AMERICAN SUZUKI MOTOR CORPORATION

August 26, 2004

**RE: GRAND VITARA/GRAND VITARA XL-7/VITARA WITH V6 ENGINE**  
**FUEL LEAK DUE TO FUEL PRESSURE REGULATOR FREEZING**

**Recall Countermeasure Kit Assembling Instruction**  
**For North American market (01MY and after)**

**1. Fuel pressure regulator replacement**

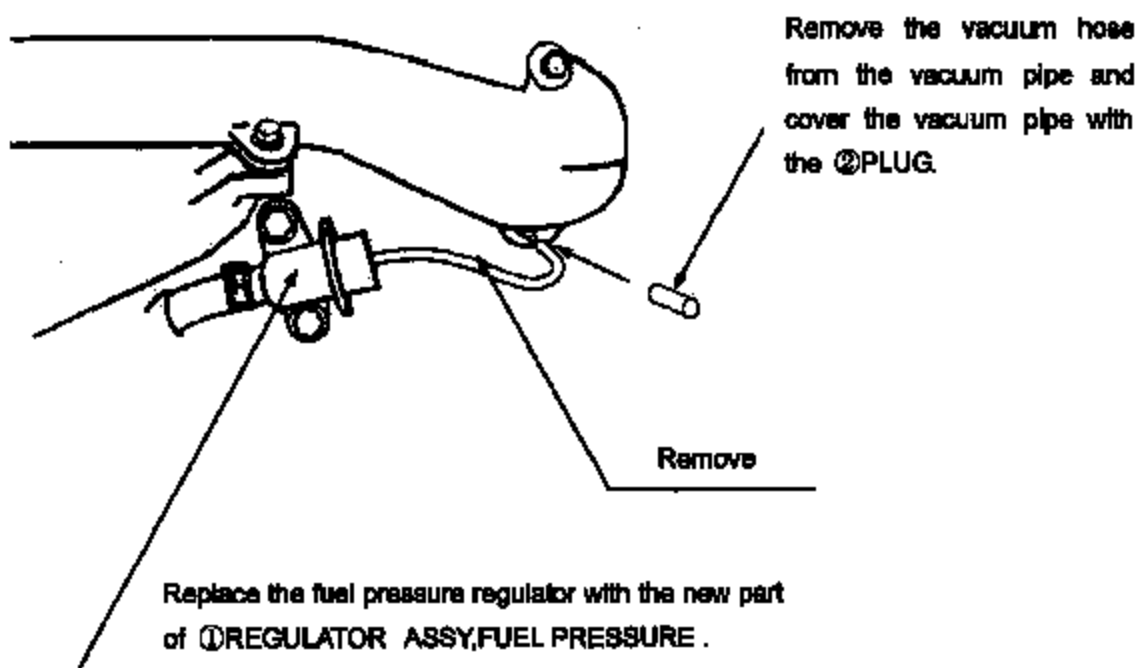
- 1) For 1999 & 2000 model year
  - (1) Change routing of the fuel pressure regulator and its vacuum hose using the new part.
  - (2) Replace the fuel delivery hose with new parts and its hose clip with the improved part.

Change routing of the fuel pressure regulator and its vacuum hose using the new part..
